Permit Application Review Report
Date: 9/9/2026

Project Name: Legacy Christian Academy Athletic Fields - Phase 1

Project PAN: P-26-031

Recommendation: Approve with 3 Conditions and 4 Stipulations

Figure 2: Site Plan

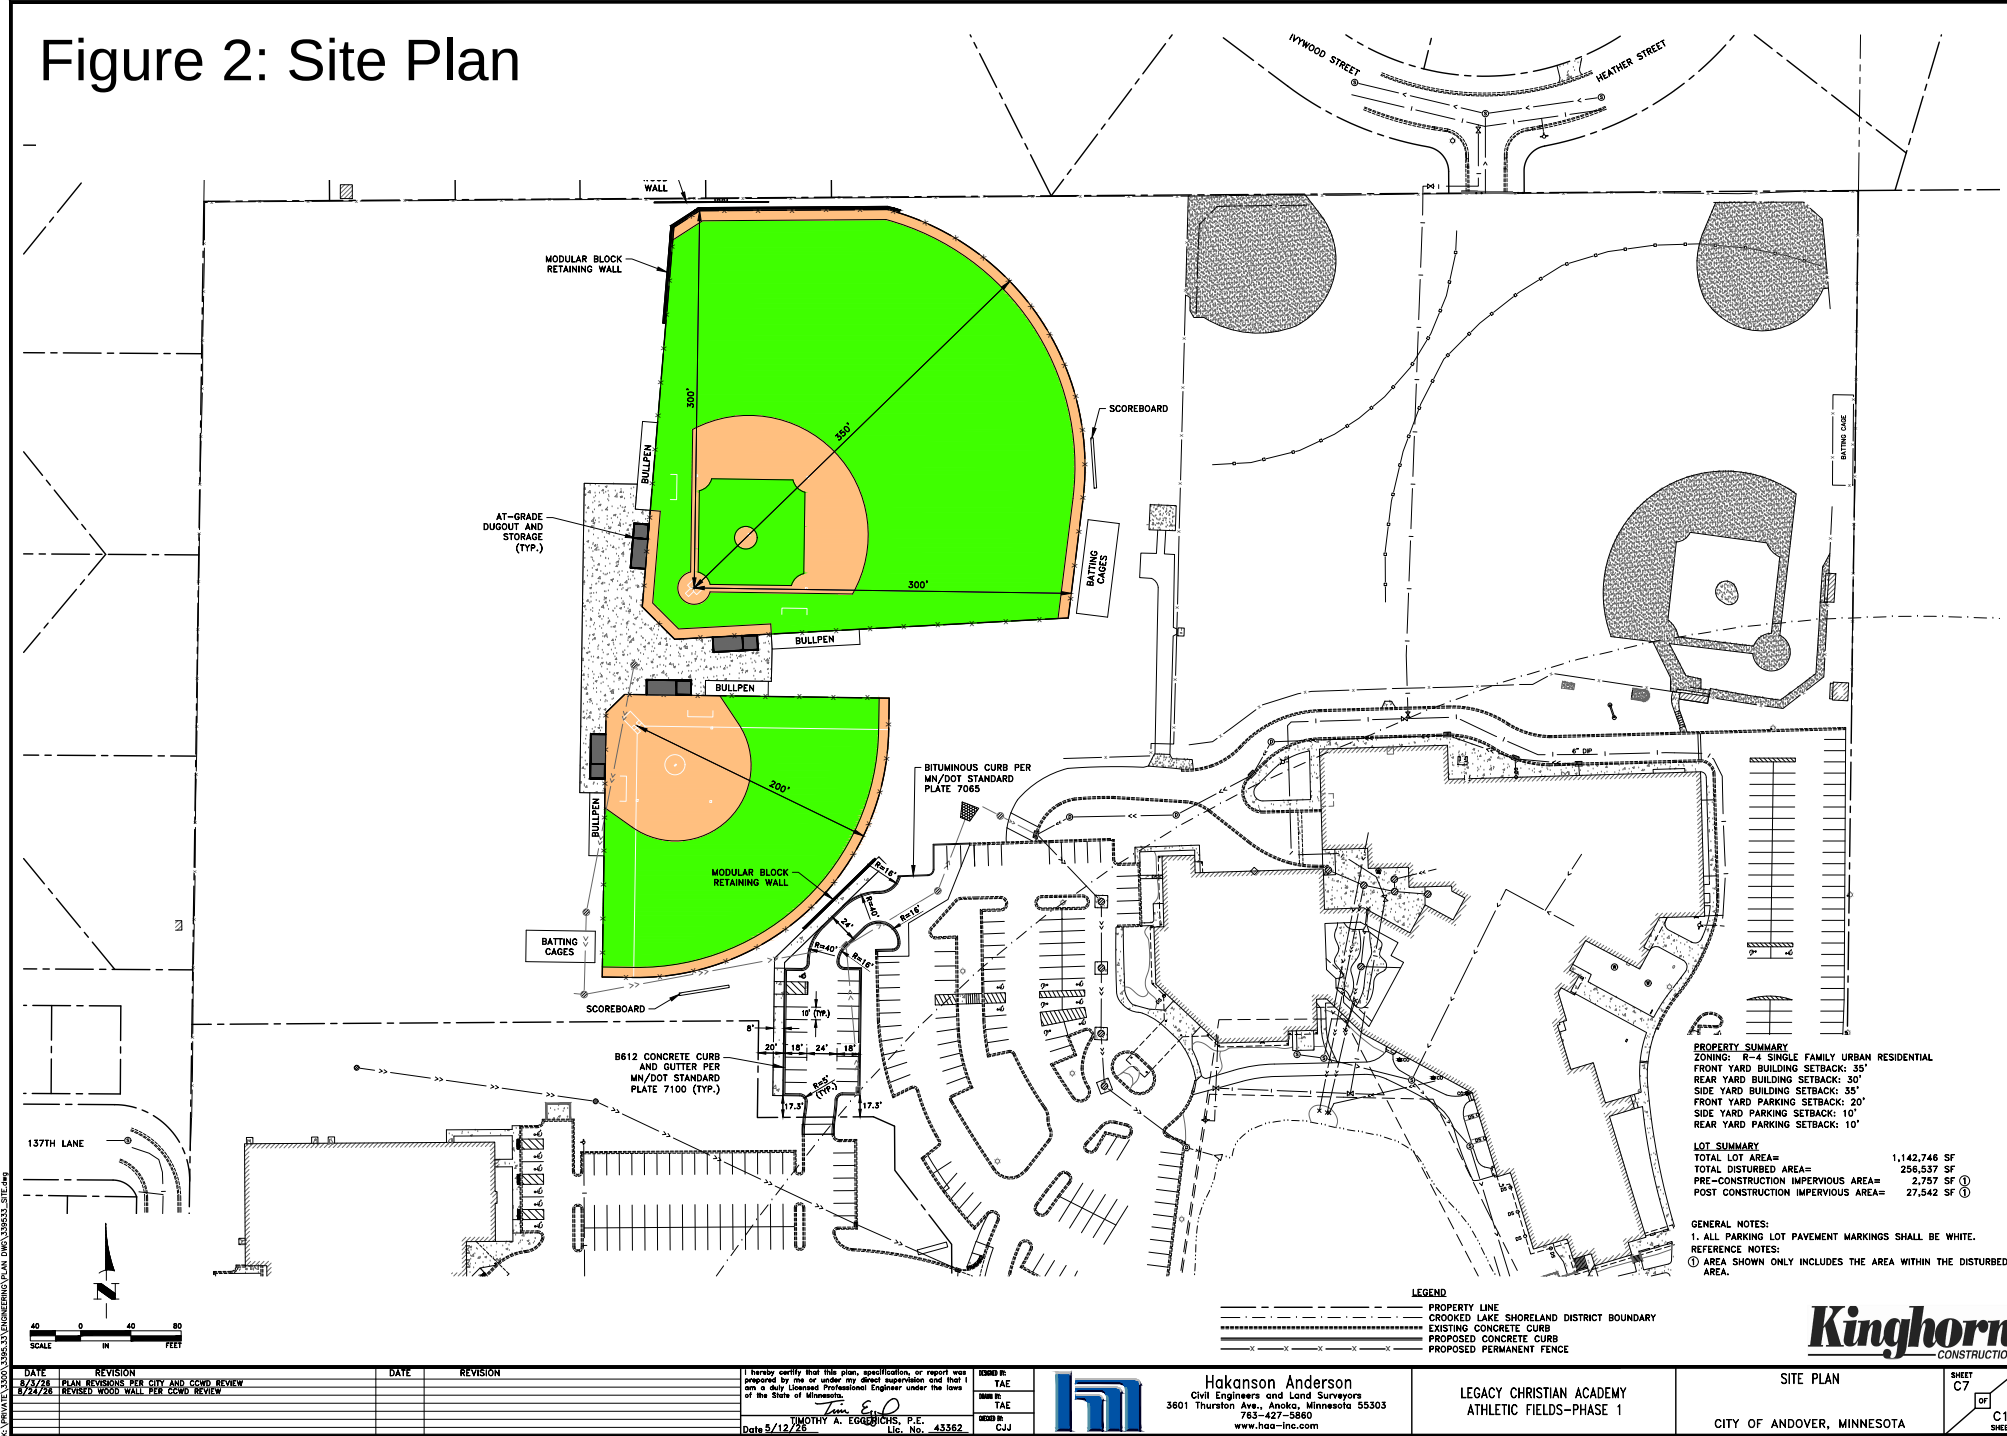
Description: The project is proposing the construction of new athletic fields, parking and stormwater management features at the Legacy Christian Academy in Andover. The project proposed to disturb 6.55 acres and create 0.62 acres of new/regulated impervious. A portion of the project drains north toward County Ditch 57 (Coon Creek), and a portion drains south toward County Ditch 54. The relevant water resource concerns are Stormwater Management (District Rule 3) and Soils & Erosion Control (District Rule 4). See attached Figure 1: Project Location and Figure 2: Site Plan.
